ALAMEDA COUNTY
HEALTH CARE SERVICES

Re: **Site Closure at Kmart, Former American National Can at 3801
E. 8th St., Oakland 94601**

This letter responds to the Rust Environment & Infrastructure Inc., (RUST), October 23, 1997 request for closure of "Area 3" at the above site. As you are aware, your office and DTSC have already issued closure letters on the other areas at the site related to underground tanks and a permitted TSDF and the only area of concern is Area 3. As part of the Sitewide Risk Management Plan (SRMP) groundwater monitoring was to continue in Area 3 to measure the effectiveness of site remediation at the adjoining former Ekotek site. Although the anticipated change in groundwater flow has not occurred after Ekotek's site remediation, no significant change in groundwater concentration or free product thickness has been observed in monitoring wells in Area 3 over the past 1 1/2 year.

RE: American National Can Company
Former Oakland, California Facility

FIGURE NO. 10

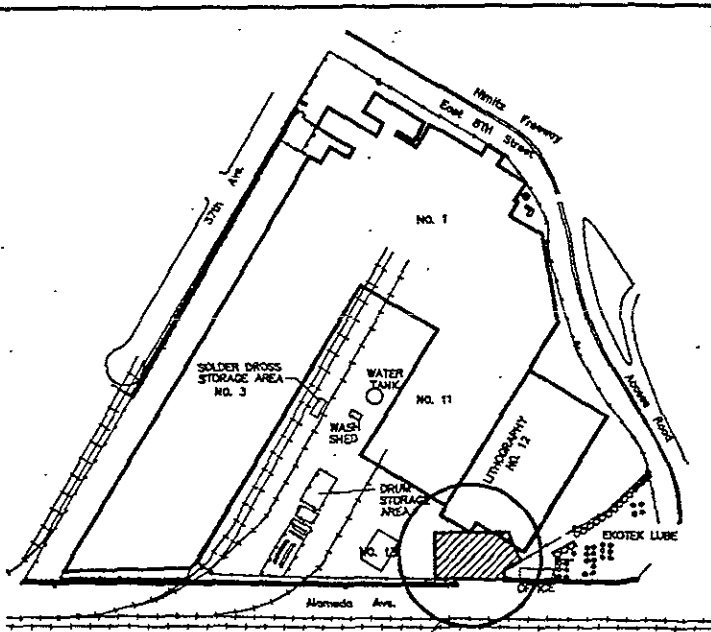
"I. Sampling Plan - Temporary Storage Area"

The submitted sampling plan for the Temporary Storage Area is incomplete. Soils in the Temporary Storage Area are subject to hazardous waste releases to the air and soil. Soils hazardous wastes are not contained according to CCR Title 22. Partial covering of soils with plastic allows vapors to be released to the air, and results in rainwater intrusion directly into stored hazardous wastes. Inadequate berming has resulted in rainwater run-off. Because containment of soils is inadequate the Department has developed the following sampling plan which the owner must implement in order to demonstrate significant contaminant releases to soils has not occurred.

Replace I.1. Sample Design and I.2 Objectives, and modify I.3 Proposed Methods, Equipment and Material as follows:

The Temporary Storage Area is divided into a grid consisting of 10 x 10 feet squares. A random generator is used to select 5 samples from each area A, B, and D. Two samples are randomly selected from area C. See Attachment B - draft closure plan Figure 10 re-worked.
